Product Change Notification

PCN-ESP K10T1 Surge Protective Device (SPD)

Item: ESP K10T1	Description 10 way PBX telecom line SPD	Replaced by: N/A
ABB Order code 7TCA085400R0130

Description of change

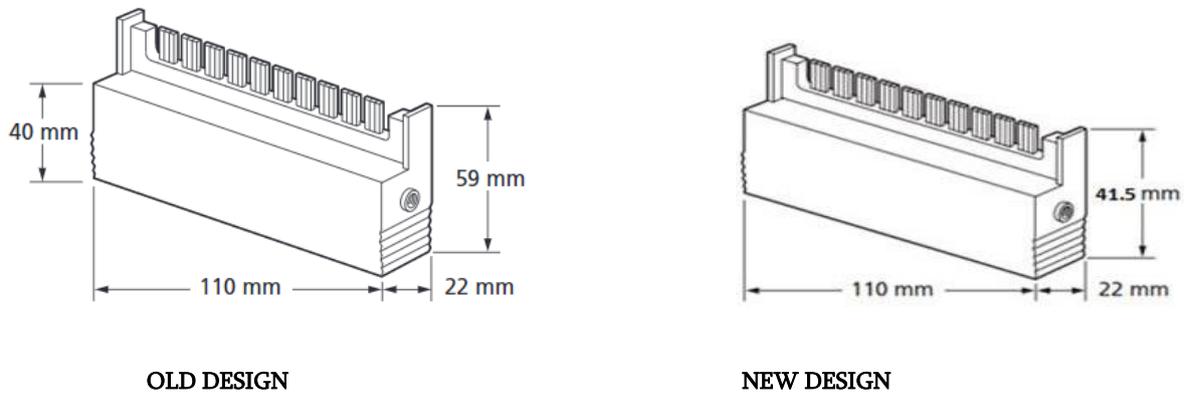
The new ESP K10T1 has a reduced height from 59mm (old design) to 41.5mm. This height reduction allows for the PBX frame lid cover to engage securely to the PBX frame once the SPD has been fitted.
